**Approval of "GESSI" Bath Mixer
(General Acceptance No. C20190095)**

Name of Manufacturer: Gessi SpA
Country of Origin: Italy
Brand: Gessi
Details of Fitting: 3/8" Single lever bath mixer
Model: 46037
Body Markings: 
Expiry Date: 22 November 2023

46037

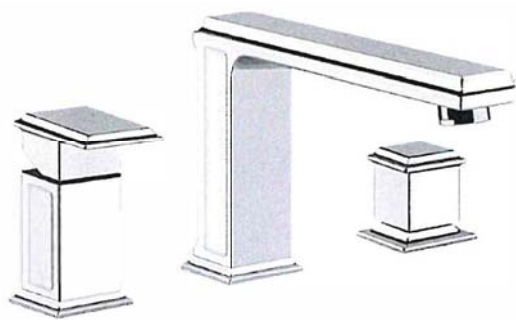
"The cold water supply to the fitting shall be drawn from the same source that supplies the hot water apparatus so as to provide a balanced pressure and to obviate the risk of scalding in the event of a restriction or failure in the water supply." AND

"The shower head or handspray should not be placed in submerged conditions and should be securely fixed to the original position after use."
